# Applicant's A.22(2A)(b) Response Statement to Louth County Council LRD009 Notice of Opinion

Residential Development with Crèche at Hill Street, Dundalk, Co. Louth

Prepared on behalf of  
Zirbac Dundalk Ltd

Figure 1 Dundalk Active Travel Project Drawing L330 OCSC XX XX DR C 0111

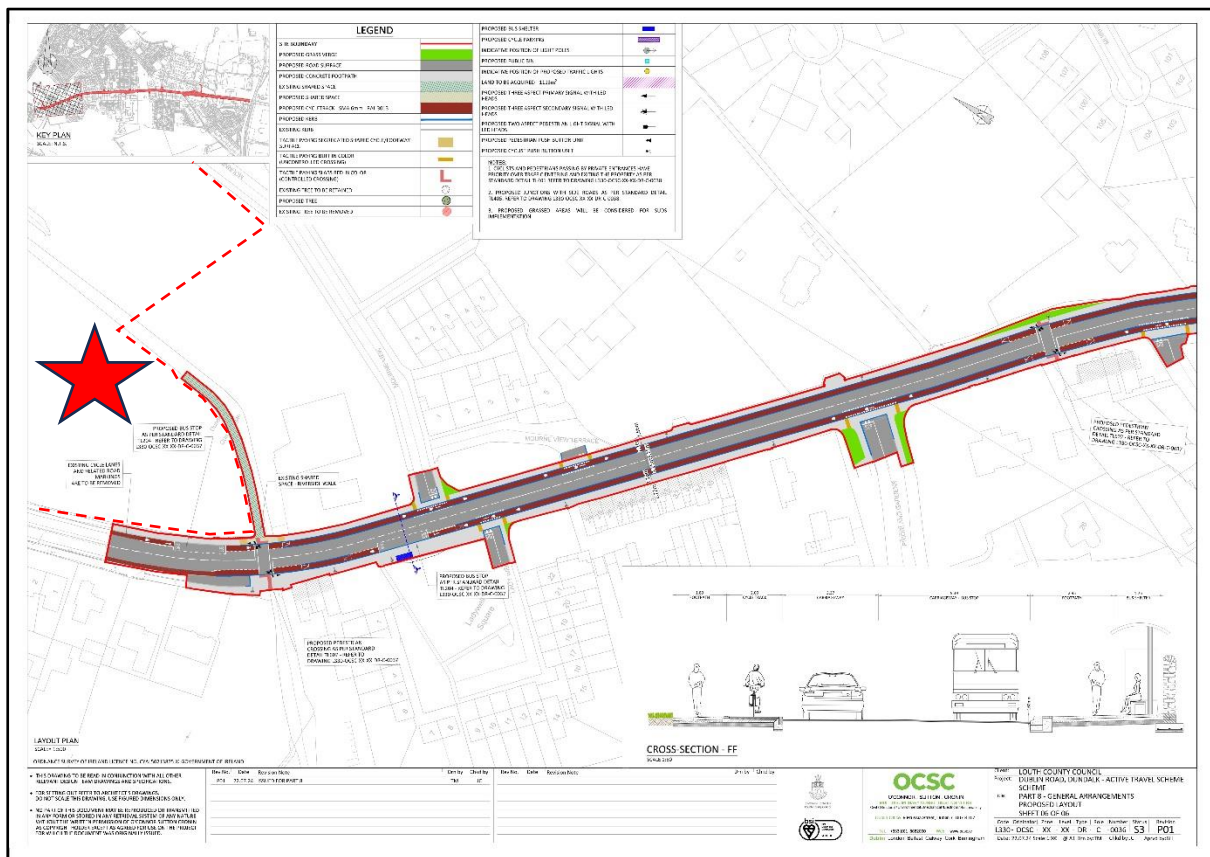
*LCC’s Active Travel Unit currently has a Part 8 Proposal for proposed works on the R132 from the location of the proposed development all the way south to the Xerox Junction. The prospective applicant should make reference to same in any future application*

The applicant is aware of the plans under LCC’s Active Travel Scheme which extend to the south eastern boundary of the application site where the existing greenway commences. The proposed development will not impede any of the plans that were on public display as illustrated below.
